# City of Richmond

**Re: Request for Quotation 4215Q – Supply and Installation of Piles at Garry Point Park - Addendum Three (3)**

GARRY POINT TALL SHIP FLOATS  
 PILE ANODE DETAIL  
 HEL PROJECT NO. 2167-003  
 REV.2 RE-ISSUED FOR ADDENDUM  
 MARCH 2, 2011

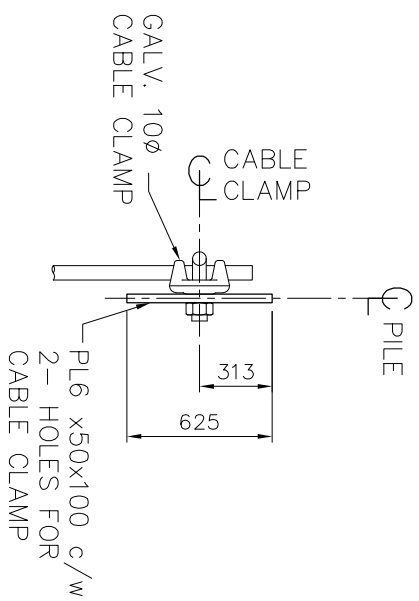
The anodes are to be 36 lb zinc anodes. They are to be a hanging type of anode and either cylindrical or square bar shaped with a maximum width of three (3) inches and a length suitable to meet a weight of 36 lbs (the length will be agreed on by the Successful Bidder and the City prior to construction). The anodes shall be hung from the pile top with a steel cable allowing them to be inspected and/or changed out without the use of divers. The cable extends from the top connection to the anode. Please see the revised detail, appended to this Addendum.
